SOUTH ELEVATION - ALONG HYDRAULIC ROAD

PROPOSED VIEW ACROSS HYDRAULIC ROAD

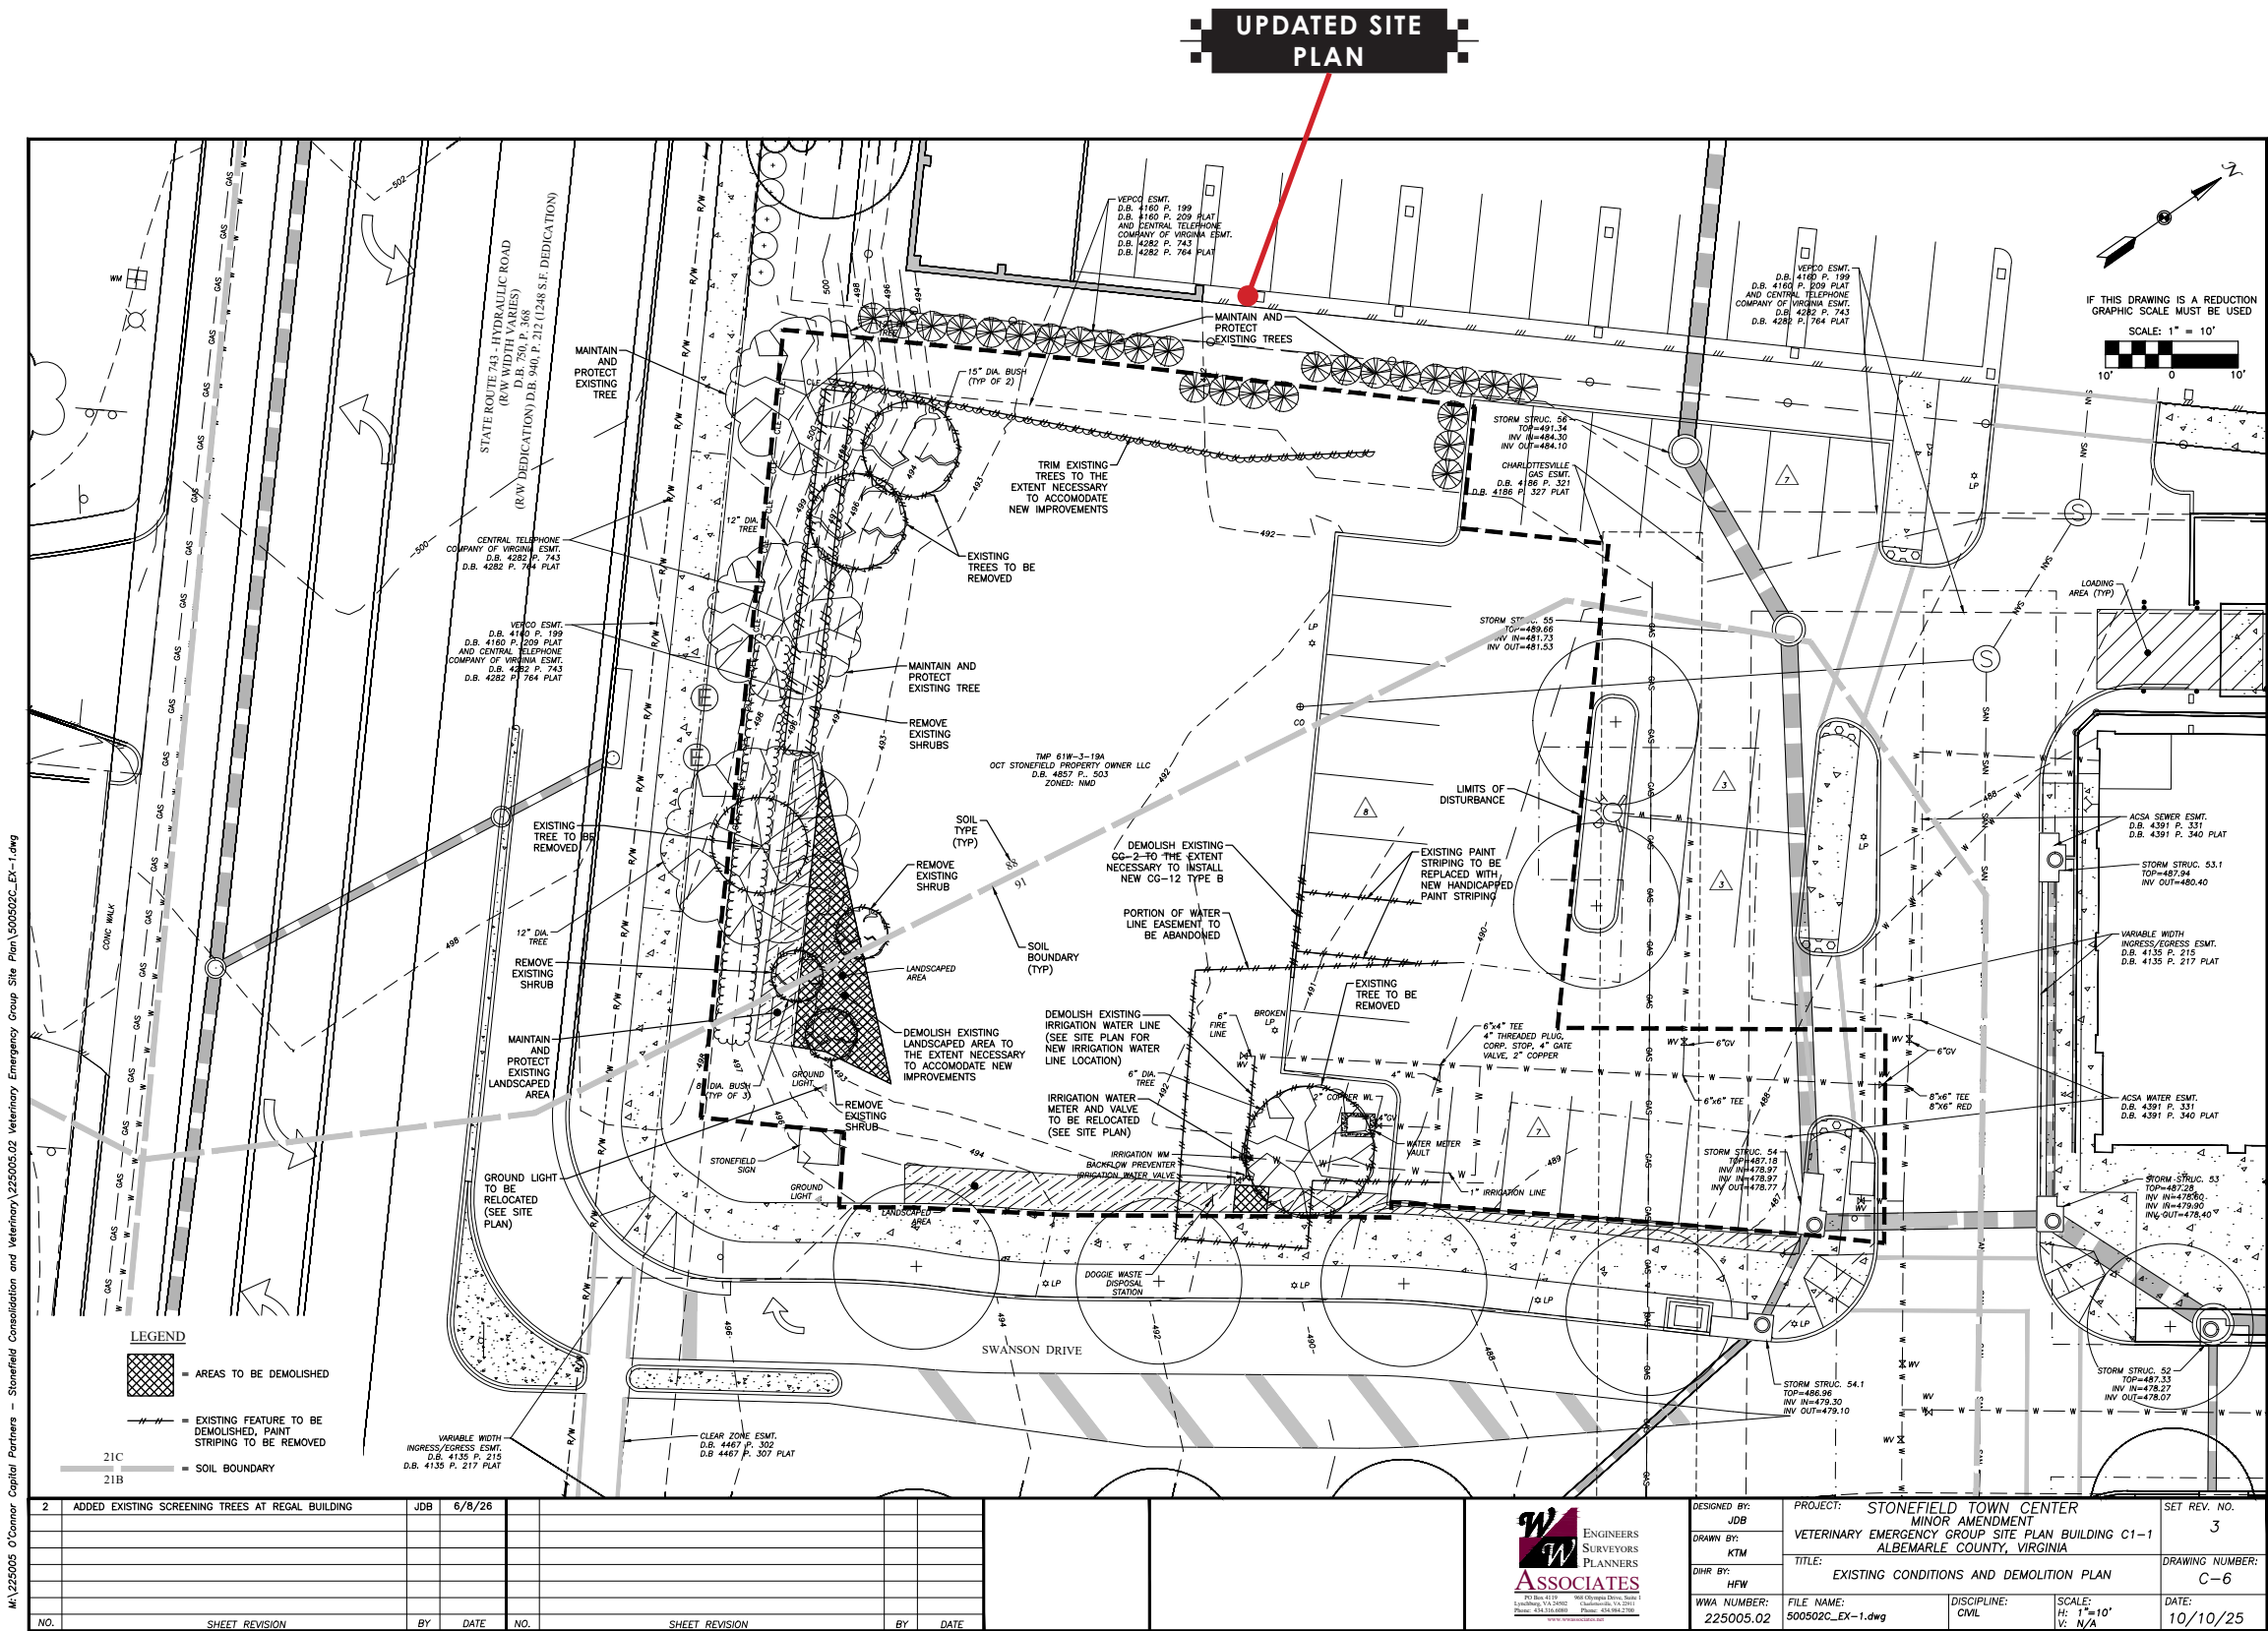
8. Revise the site/grading plan to show the row of Arborvitae along the cinema.

9. Provide additional information in the plan to show how trimming of the Arborvitae will result in an appropriate appearance and a health condition for the trees.

- Civil has advised that the existing Arborvitae are far enough from the proposed site wall that the root system will not be damaged. They will be trimmed back from the new construction but should maintain their height and screening of Regal Cinema.

UPDATED SITE PLAN

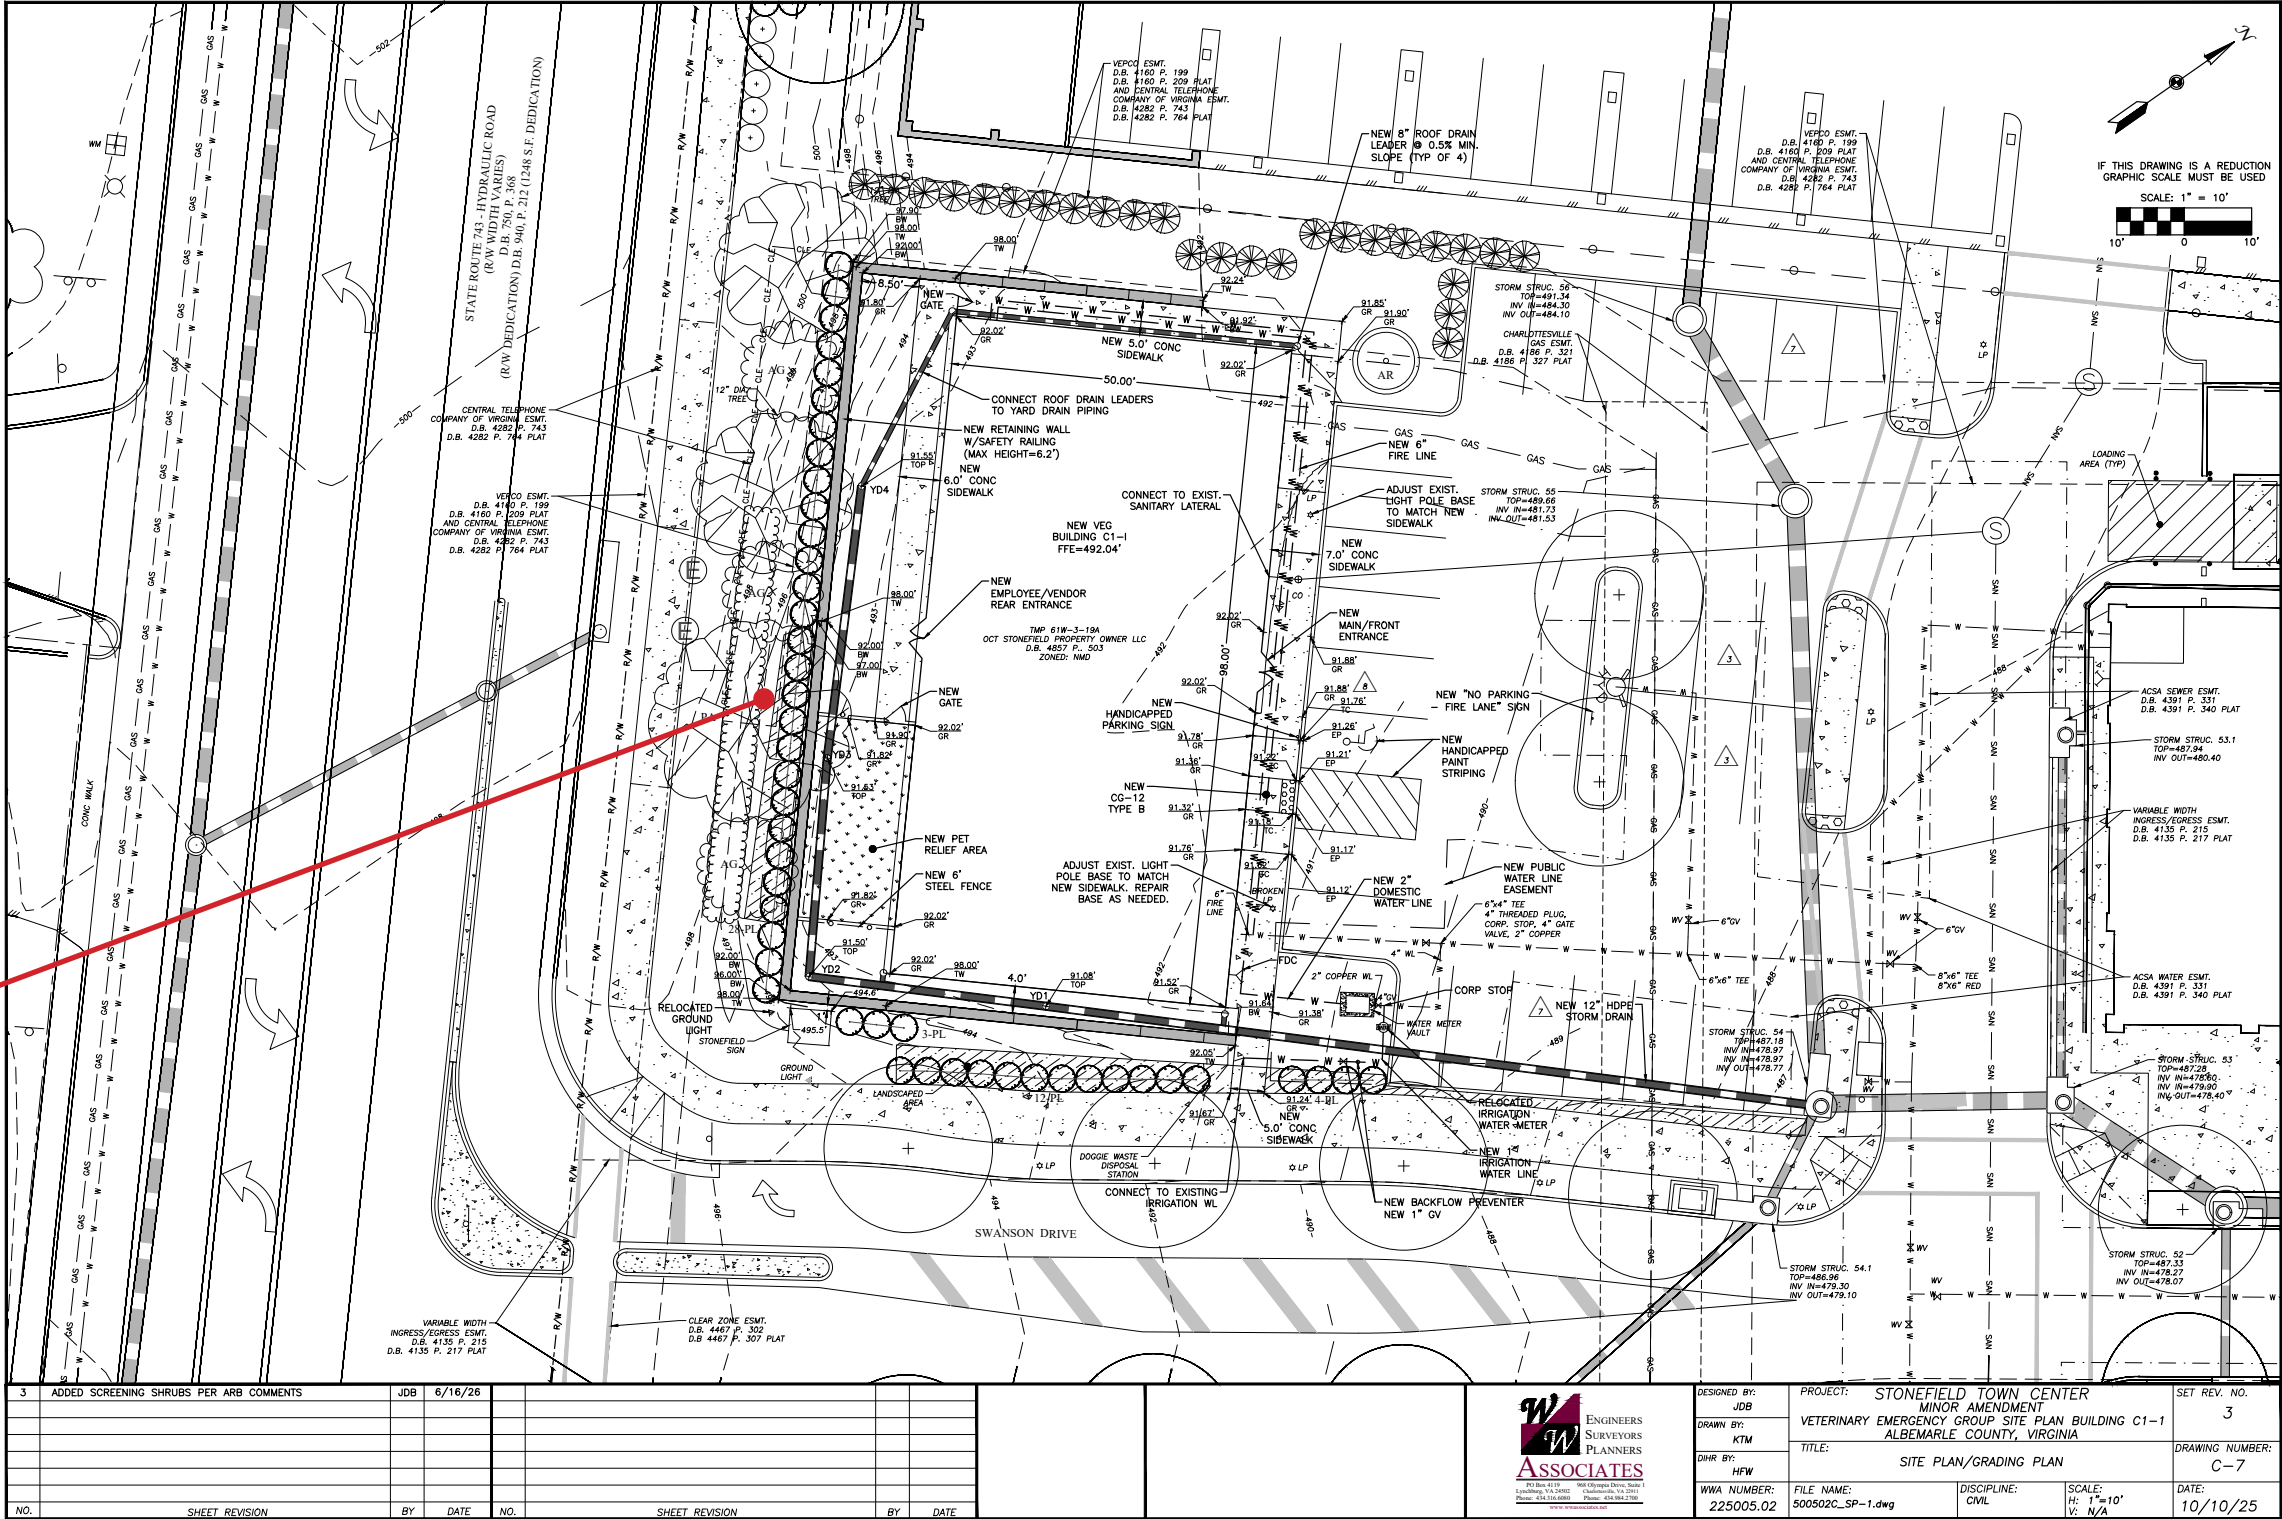
10. Revise the retaining wall material and color to coordinate closely with the adjacent Stonefield sign and the building across Swanson Drive.
11. Revise the site plan to include details describing the appearance of the safety rail.

- Additional plantings along the site wall will create layers of visual interest along the Entrance Corridor and shield the site wall and fence.

ADDITIONAL PLANTINGS IN THE SITE PLAN
TO PROVIDE LAYERS OF INTEREST WITH THE
SITE WALL AND FENCE.

FENCE MODEL IS MANCHESTER BY
CATALYST FENCE SYSTEMS AND APPEARS AS
RENDERED.

UPDATED SITE WALL DETAILS

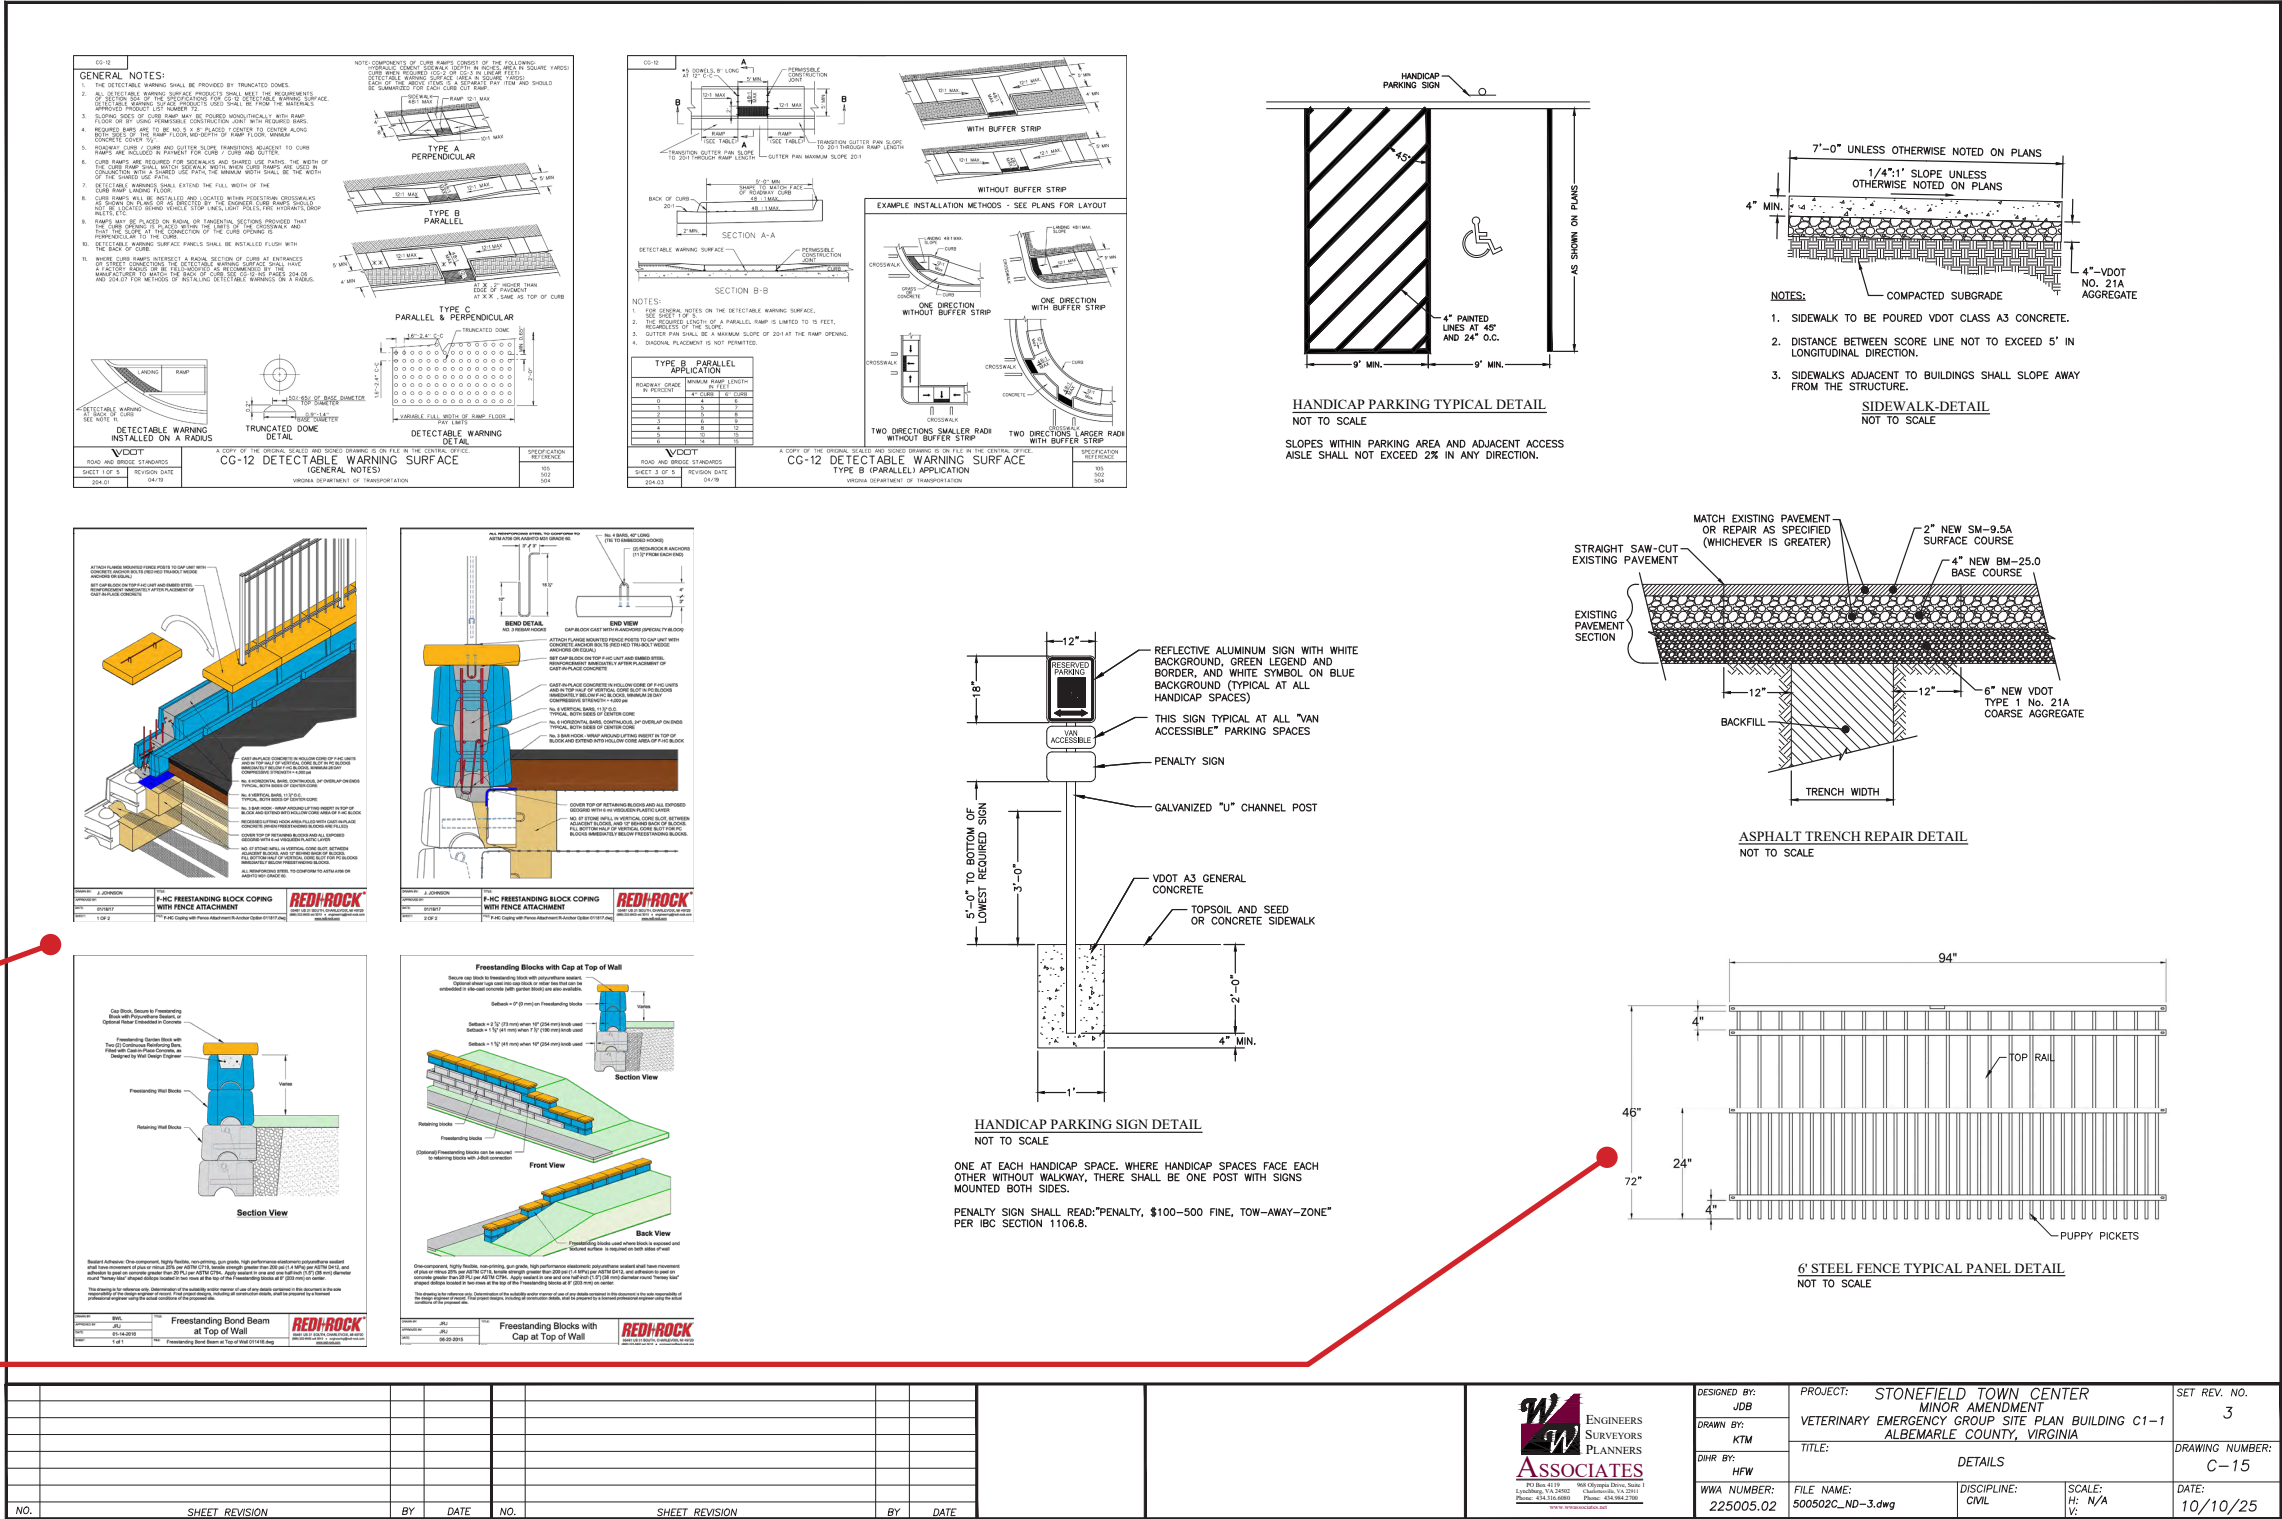
- 10. Revise the retaining wall material and color to coordinate closely with the adjacent Stonefield sign and the building across Swanson Drive.
- 11. Revise the site plan to include details describing the appearance of the safety rail.

- Additional details of the top free-standing, double-sided blocks for the site wall and installation of fence onto the top cap.
